SUBJECT: ISSUANCE OF AMENDMENT NO. 15 TO FACILITY OPERATING LICENSE
NO. NPF-63 - SHEARON HARRIS NUCLEAR POWER PLANT, UNIT 1,
REGARDING CYCLE 3 RELOAD WITH VANTAGE 5 FUEL
(TAC NO. 72947)

AMENDMENT NO. 15 TO FACILITY OPERATING LICENSE NO. NPF-63 - HARRIS, UNIT 1

ATTACHMENT TO LICENSE AMENDMENT NO. 15

**FIGURE 2.1-1
 REACTOR CORE SAFETY LIMITS - THREE LOOPS IN OPERATION**

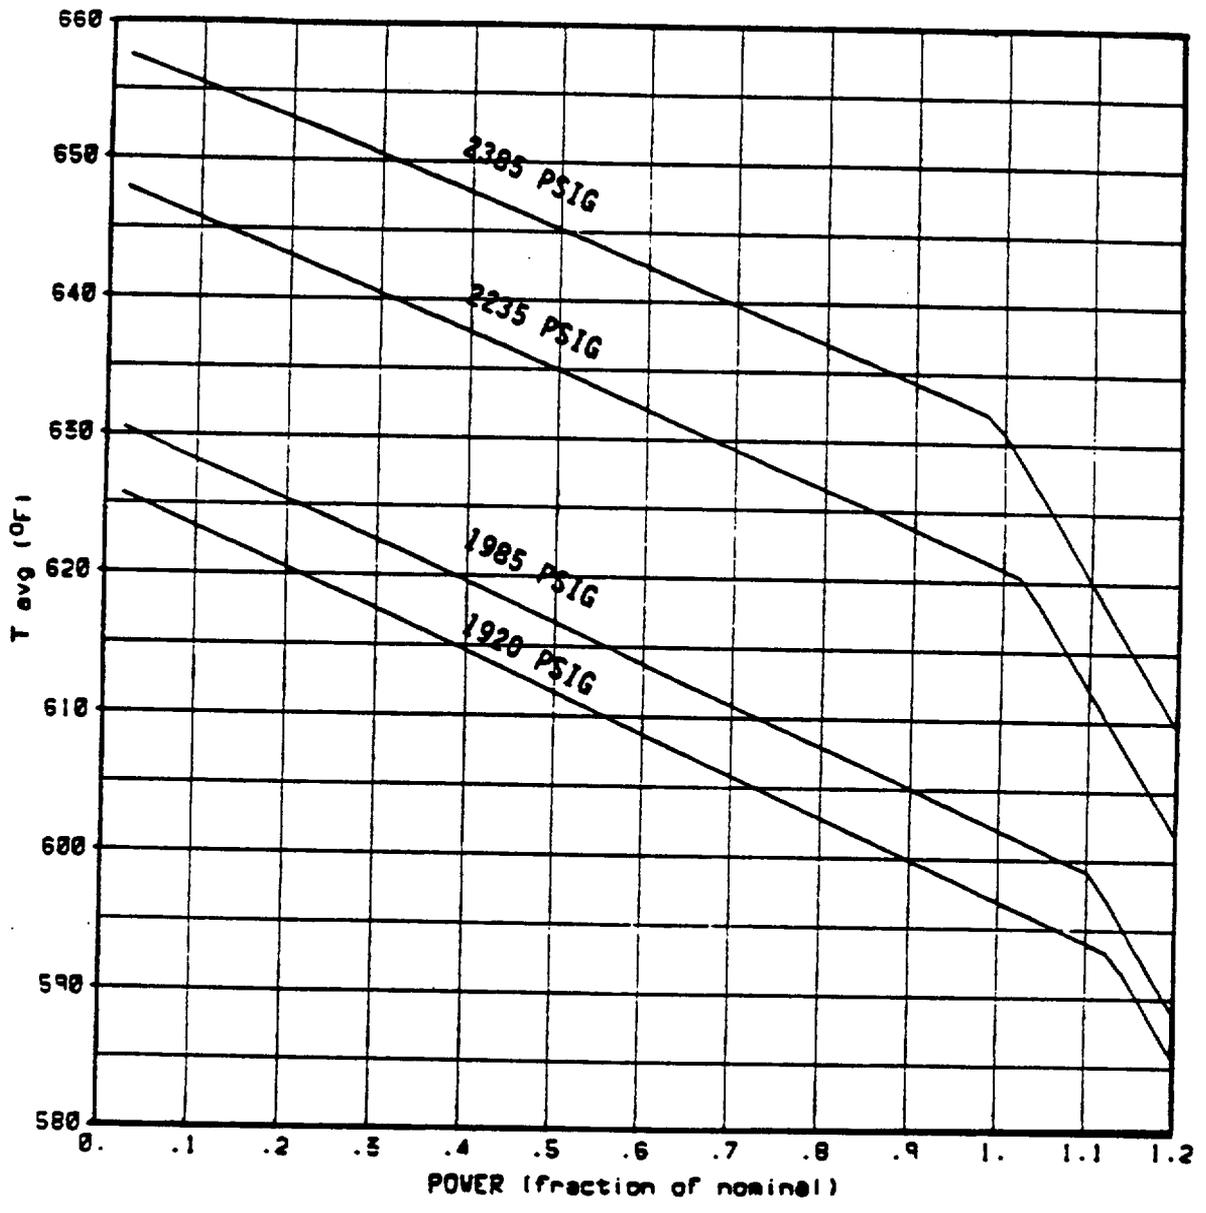
3.1 Core Safety Limits (Figure 2.1-1, 3/4.2.3 and Bases 2.1.1, 3/4.2, 3/4.2.5, 3/4.4.1)

The core safety limits are revised to reflect the use of VANTAGE 5, ITDP, WRB-1 (LOPAR fuel) and WRB-2 (VANTAGE 5 fuel) DNBR correlation and increased F_H (1.62 for LOPAR fuel and 1.65 for VANTAGE 5 fuel). Since the core safety limits are calculated based on the approved WCAP-10444-P-A, ITDP method, DNBR correlations and acceptable results of transient and accident analyses, the staff concludes that the revised core safety limits are acceptable.

3.2 Overpower/Overtemperature Setpoints (Figure 2.1-1, Table 2.2-1)

Since overpower and Overtemperature setpoints are revised to maintain consistency with the analyses to support the reload application, the revised overpower and overtemperature setpoints are acceptable.

FIGURE 3.2-2
 K(Z) - LOCAL AXIAL PENALTY FUNCTION FOR $F_0(Z)$

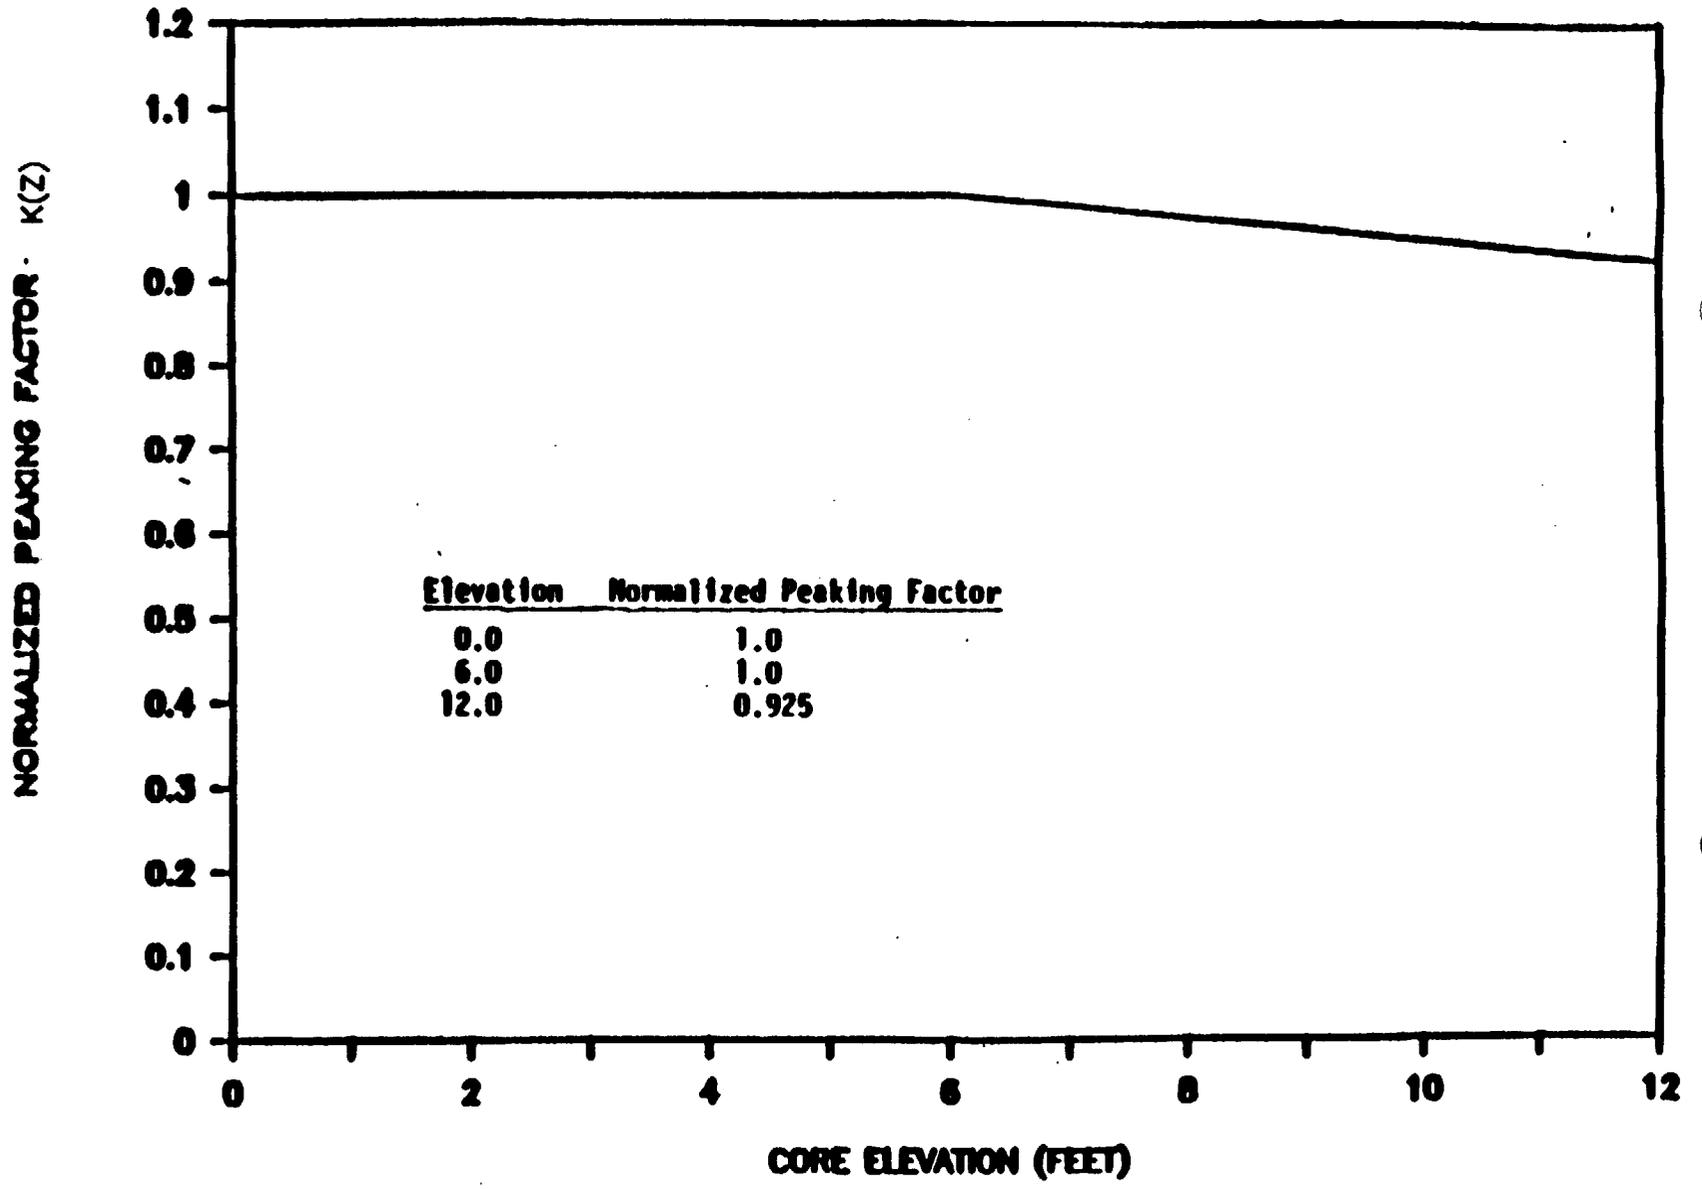
3.5 Hot Channel Factor- F_Q (3.2.2, 4.2.2.2, 4.2.2.3, 4.2.2.4, Figure 3.2-2 and Bases 3/4.2)

The maximum hot channel factor- F_Q is increased from 2.32 to 2.45 to allow for greater operational flexibility due to the use of VANTAGE 5 fuel. Since the F_Q of 2.45 was used in the analysis to support the reload application, the staff concludes this change is acceptable.
